CITY OF HENDERSONVILLE CURRENT PLANNING COMMITTEE

CITY OF HENDERSONVILLE AGENDA ITEM SUMMARY PLANNING DIVISION

TITLE OF ITEM: Rezoning: Conditional Zoning District – Brooklyn Townhomes (P24-62-CZD) – Matthew Manley, AICP – Long-Range Planning Manager

STAFF SITE PLAN REVIEW – SUMMARY COMMENTS

SHEET
CZD
1.0

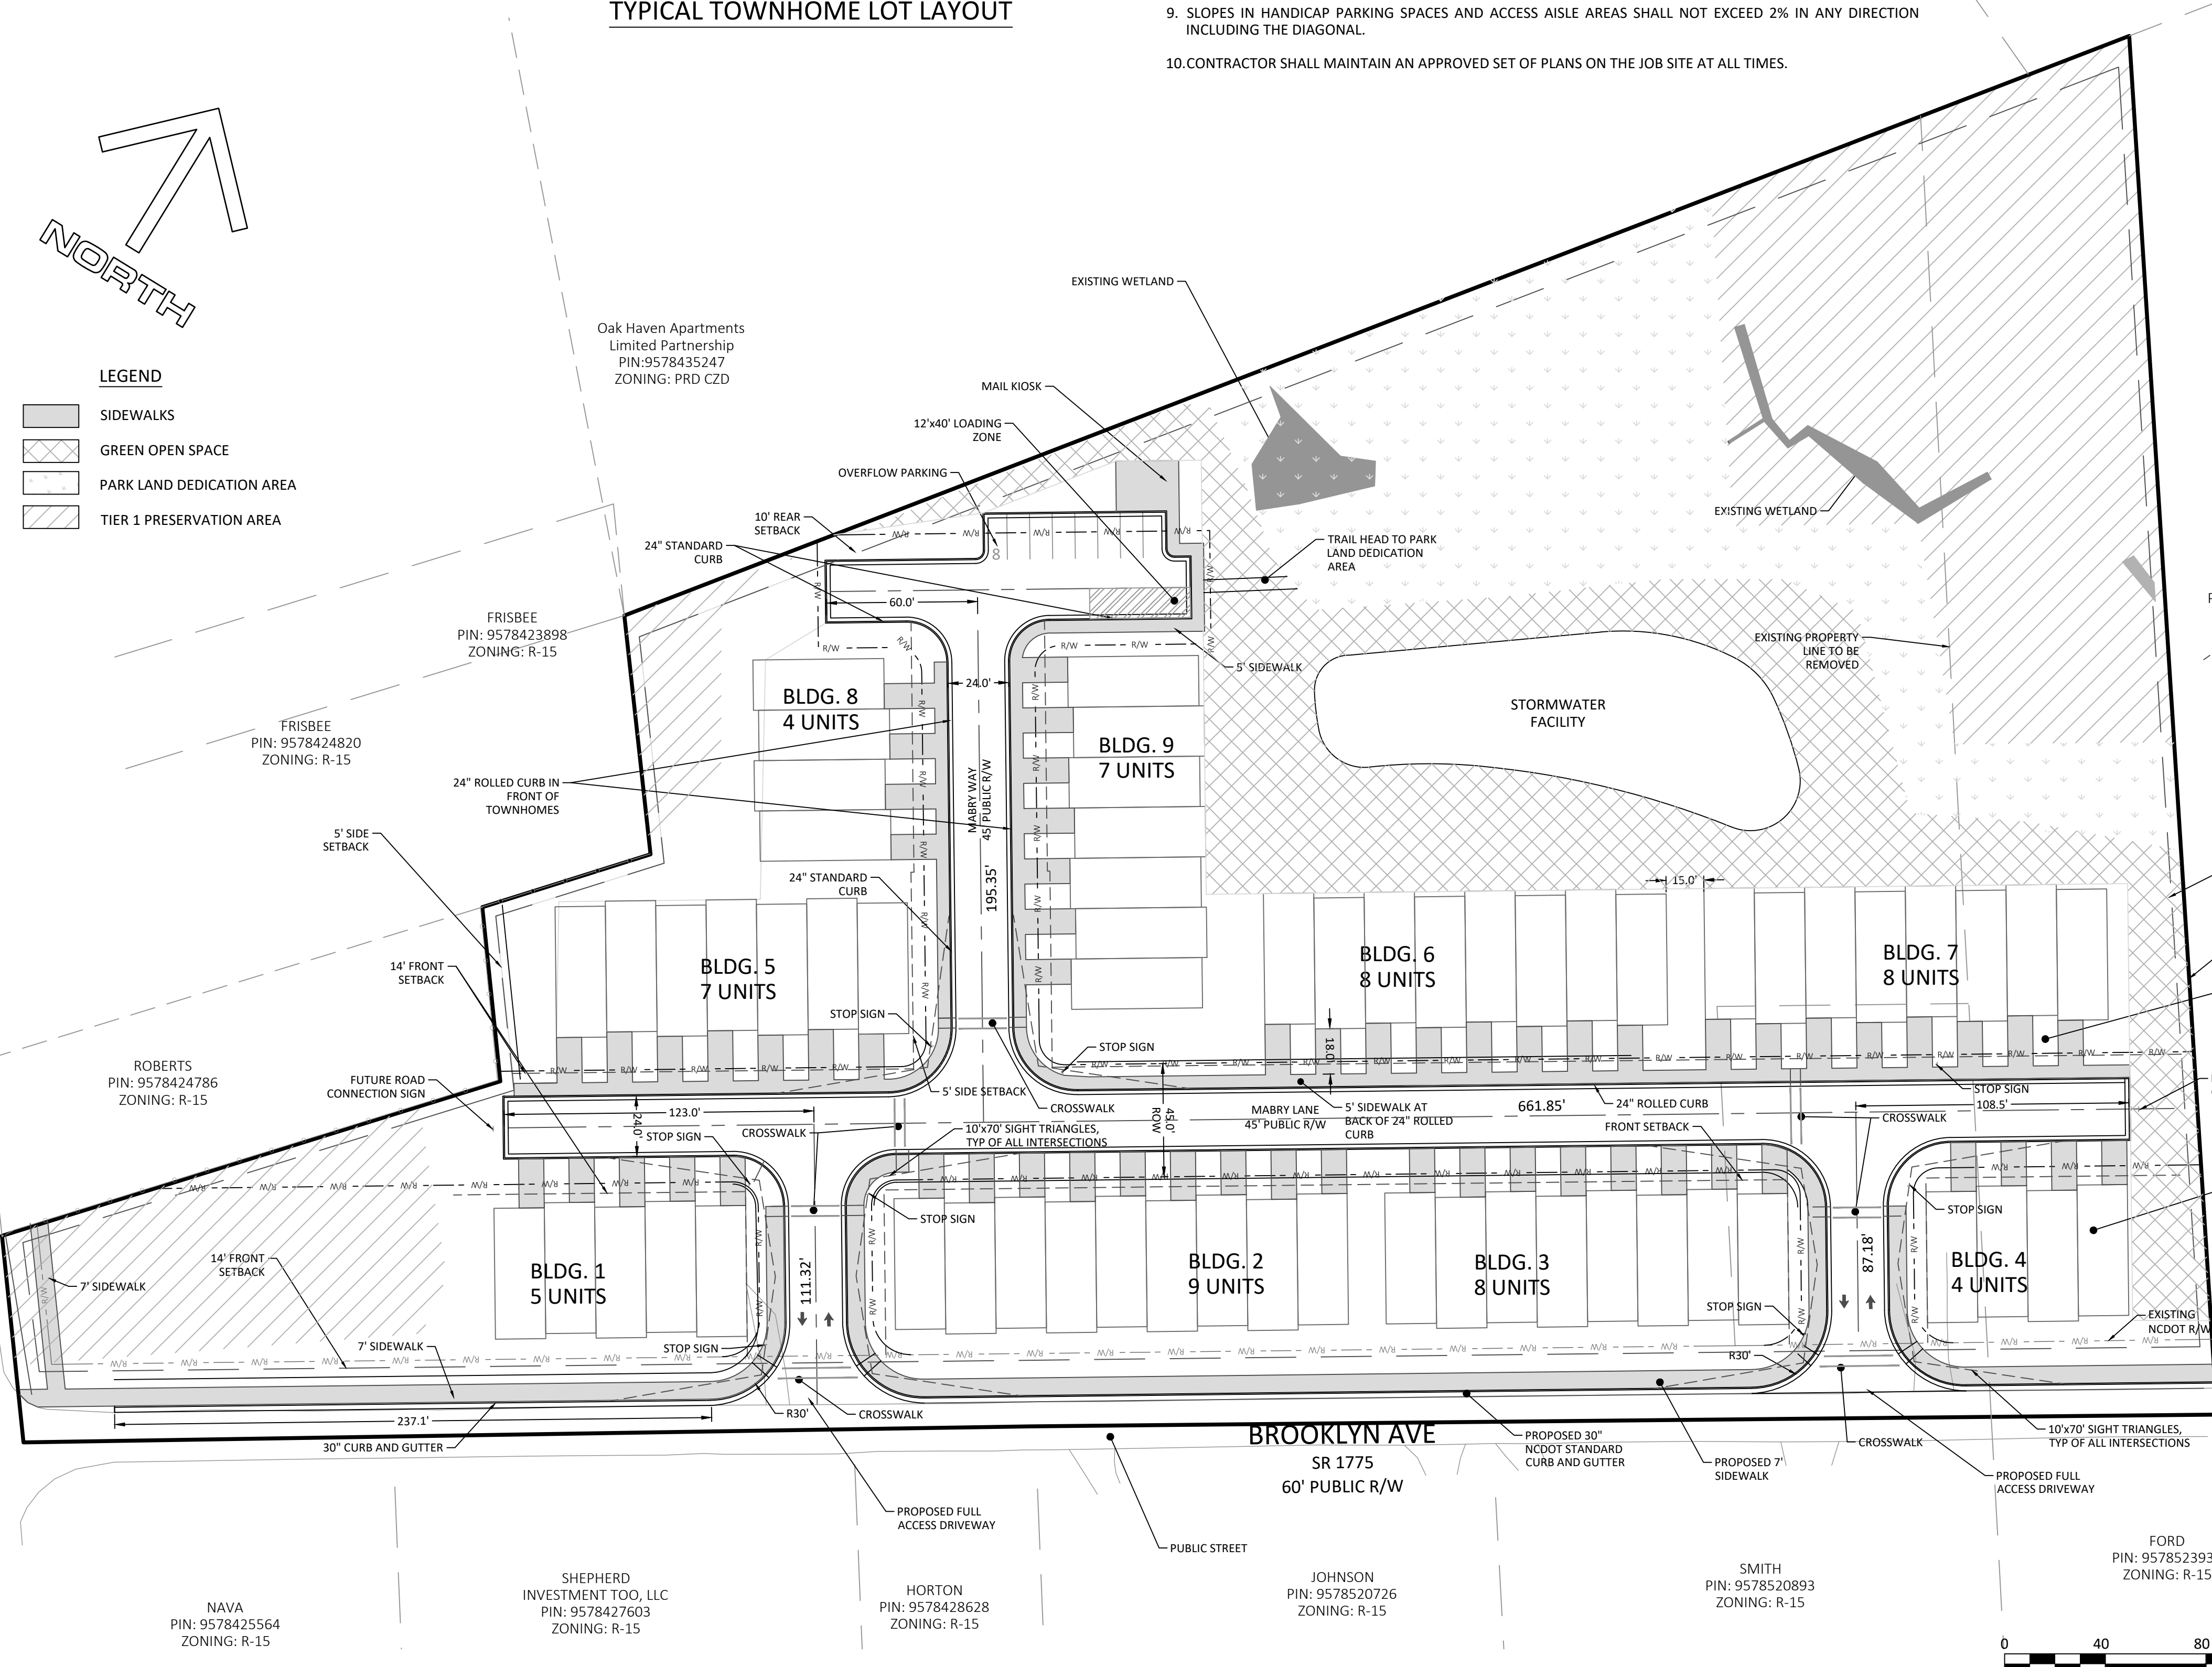
- The site plan accompanying this petition meets the standards established by the Zoning Ordinance for UR-CZD and Subdivision Ordinance for Major Subdivision with the following exceptions.

- These outstanding items shall need to be resolved as part of the CZD process.
 - Developer-Proposed Condition is needed in order to plant the proposed medium-size street trees along Brooklyn Ave. As shown this does not meet our standards, however the City would consider a condition given feedback received from NCDOT. If no condition is offered, the Developer will have to meet the Zoning Ordinance standards at the time of Final Site Plan [Unresolved – Resolve at CZD]

- These outstanding items shall be resolved at the time of Final Site Plan and/or Preliminary Plat.
 - Building elevations lack the specifications and details to reasonably determine if they are compliant with design standards. [Unresolved – resolve at Final Site Plan].

- Loading Zone is encumbering the public street ROW. A condition and Fire Marshal approval would be needed to locate as shown. Alternatively, since On-Street Parking is required, you can utilize On-Street Parking to comply with Loading Zone requirements. [Unresolved – resolve at Final Site Plan]

- Bulb-Outs required at crosswalks per 5-25-5.15 [Unresolved – resolve at Final Site Plan]
 - Pedestrian walkways should connect to front entrance of each unit per 5-25-5.15 [Unresolved – resolve at Final Site Plan]

- On-street parking required where it can be provided per 5-25-5.16 b) [Unresolved – resolve at Final Site Plan]
 - Details needed to illustrate the intent and standards for the development of common space are met per 5-25-5.20 [Unresolved – resolve at Final Site Plan]

- Tier 2 Tree Canopy Preservation area may overlap with area designated for Parkland Dedication (if accepted by City). [Unresolved – resolve at Final Site Plan]

- Tree Credits allowed under Article 15 cannot be applied to tree plantings required per Sec. 5-25, i.e. Street Trees, Parking Lot trees, and Common Space trees. [Unresolved – resolve at Final Site Plan]

- Street Trees are required on all internal and external streets [Unresolved – resolve at Final Site Plan]
 - A waiver of the Fee-in-Lieu for Parkland Dedication cannot be waived during the CZD process.

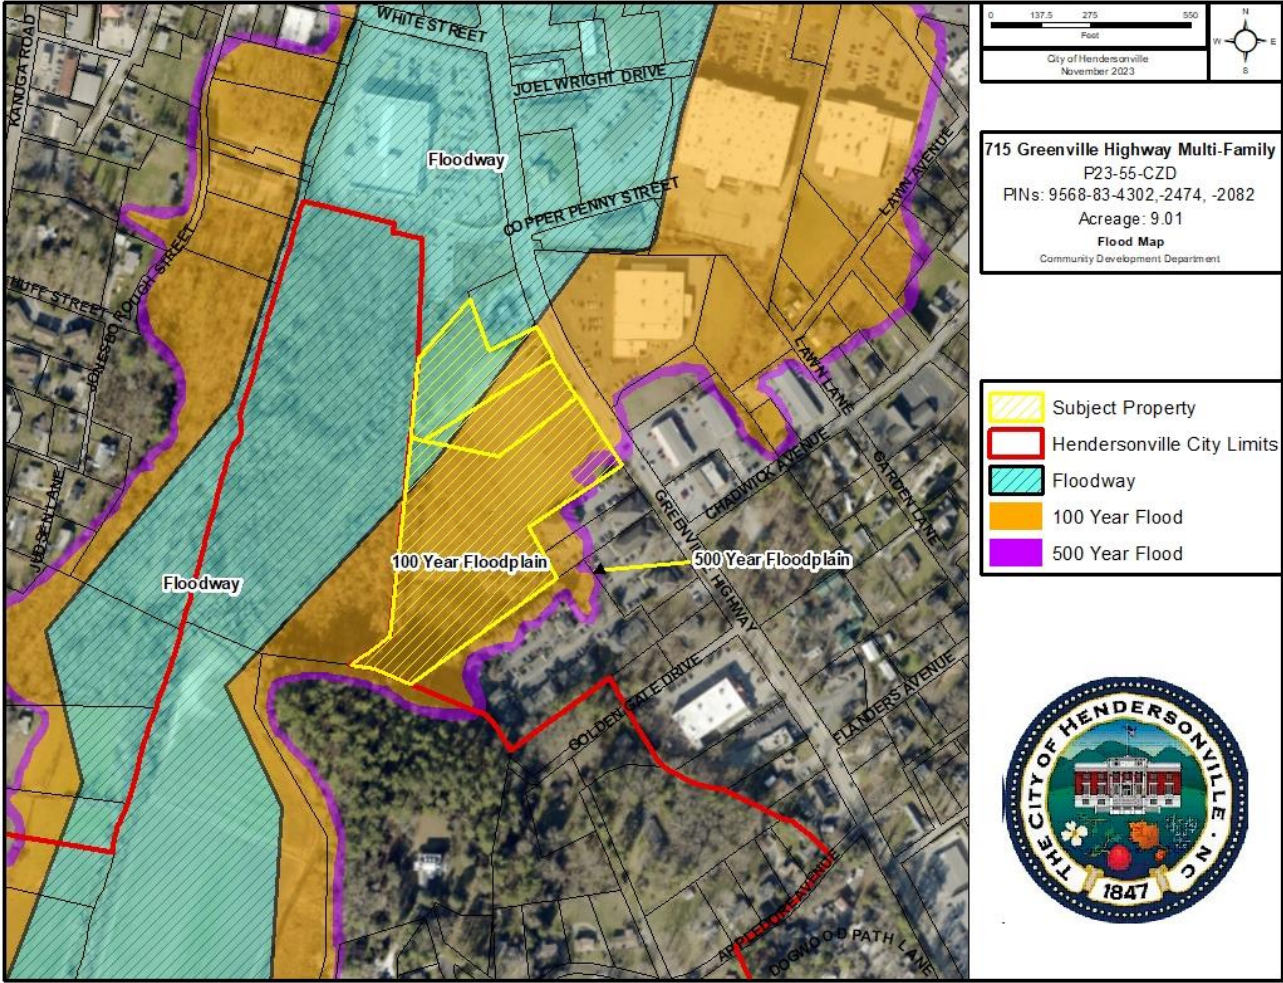
- Reviewing historic aerial imagery and available documents. It appears the site has had quite an extensive amount of grading throughout the years. It also appears that fill has been placed on the site as well. (photo below from 2010)

- Per Article 17, this project would be considered “redevelopment” in accordance with section “17-2-4 - Redevelopment in the floodway and special flood hazard area”. The ordinance states “The proposal is to redevelop an existing developed site as of the date of this ordinance evidenced by substantial coverage of the site by buildings, fill, gravel or paved drives or parking areas or other impervious surfaces.”

- Historically, some areas of the city's planning jurisdiction were developed despite the fact that they lie within the 100-year floodplain. In order to address concerns about urban blight, section 17-2-4 allows redevelopment to occur on existing developed sites which no longer function as natural flood plain and when such redevelopment will not result in any further loss of flood-plain functionality. Where feasible, redevelopment proposals should demonstrate an improvement in the site's functionality as a flood plain. In light of this intent, redevelopment of existing developed sites shall be permitted within the floodway and special flood hazard area only when the applicant has satisfactorily demonstrated that they meet the requirements of section 17-2-4.

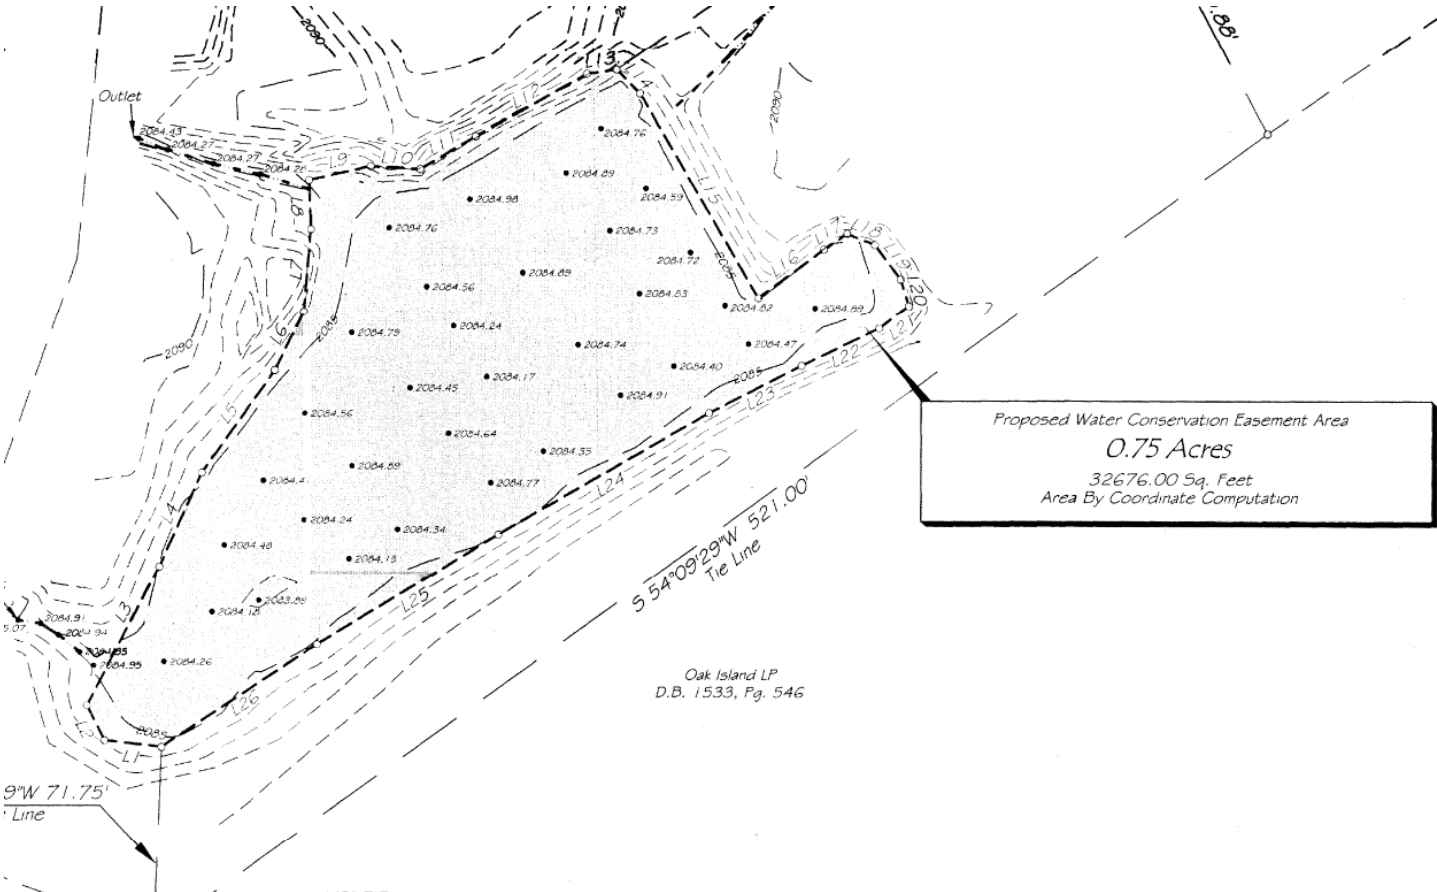
- The property does have a blueline stream along the western property edge where a stream buffer is required. The proposed development shows the 30' stream buffer and 20' transitional zone on the site plan. One section of their plan does show 6 parking spaces that are proposed to be located in the 20' transitional zone. They are proposing that this parking utilize a pervious material which is allowed by the ordinance. This is the only proposed intrusion into the stream buffer or transitional area.
- The site also has delineated wetlands along their western property boundary.

- There is an existing pond on the site that is under a water conservation easement. The easement can be found in Deed Book 1668 Page 98 and on Plat Book 2016 Slide 10216. The deed was recorded on June 21st, 2016. The proposed development is not proposing to impact this easement area. The easement area is also associated with work that was done in accordance with Army Corp Permit SAW-2014-00219 from October 22nd 2014.
